# Access Compliance Report

## Public Rights-of-Way

### (Curb Ramps)

Intersection ID: 3215	Main Street: BELLMORE_CT	Cross Street: OLD_BRIDGE_LN	Location: S
ADA ID: DA858639FDBB	Ramp Type: Perp	Initial Pass/Fail: Pass	Overall Compliance: No
		Severity Score: 0

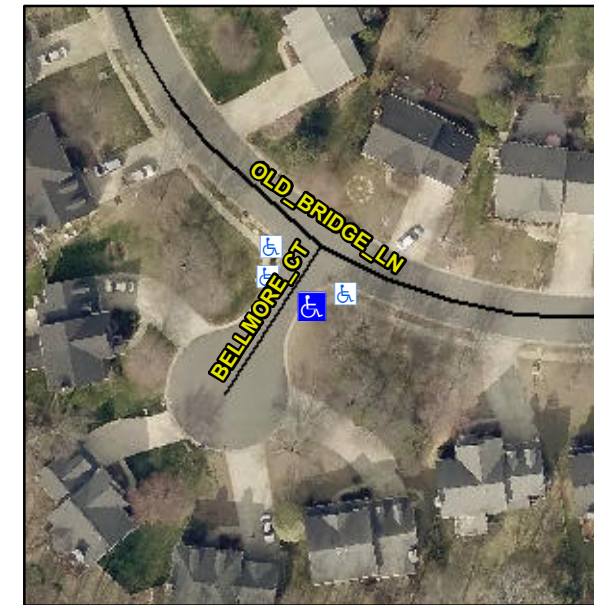
**Not Found, R304.2.1**

Compliance	Description	Data	Compliance	Description	Data
N/A	Ramp Length (in)	47.0	Yes	Ramp Slope (%)	6.2
Yes	Ramp Width (in)	48.0	Yes	Ramp XSlope (%)	0.3
N/A	Flare Type LT	Sloped	N/A	Flare Type RT	N/A
N/A	Flare Slope LT (%)	3.7	N/A	Flare Slope RT (%)	0.9
N/A	Flare Traversable LT?	No	N/A	Flare Traversable RT?	No
No	Landing Length (in)	46.0	Yes	DWS Provided?	Yes
Yes	Landing Width (in)	48.0	Yes	DWS Contrast?	Yes
Yes	Landing Slope (%)	1.4	Yes	DWS Length (in)	25.5
Yes	Landing X Slope (%)	1.4	Yes	DWS Full Width?	Yes
N/A	Landing Curb? (Y/N)	No	Yes	DWS Offset (in)	2.0
N/A	Shared Landing?	No			
Yes	Gutter Ponding?	No	Yes	Gutter Slope (%)	2.1
Yes	Gutter Lip Ht (in)	0.0	Yes	Gutter X Slope (%)	0.0
N/A	Painted X Walk1?	No	N/A	Painted X Walk2?	N/A
	X Walk 1 Direction	To NW		X Walk 2 Direction	N/A
N/A	X Walk 1 Width (in)	N/A	N/A	X Walk 2 Width (in)	N/A
	X Walk 1 Slope (%)	3.4		X Walk 2 Slope (%)	N/A
	X Walk 1 X Slope (%)	3.4		X Walk 2 X Slope (%)	N/A

N/A	Ramp inside XWalk1?	N/A	N/A	Ramp inside XWalk2?	N/A
	Road Slope (%)	N/A	N/A	Clear Space?	Yes
	Road X Slope (%)	N/A	N/A	Clear Space to XWalk (in)	N/A
Yes	Any Obstructions?	No	Yes	Storm Grate/Utility Hazard?	No
	Obstruction Type			Storm Grate/Utility Type	
			N/A		N/A
			Yes	Surface Condition? (G/P)	Good

**Remove & Replace Entire Ramp.**
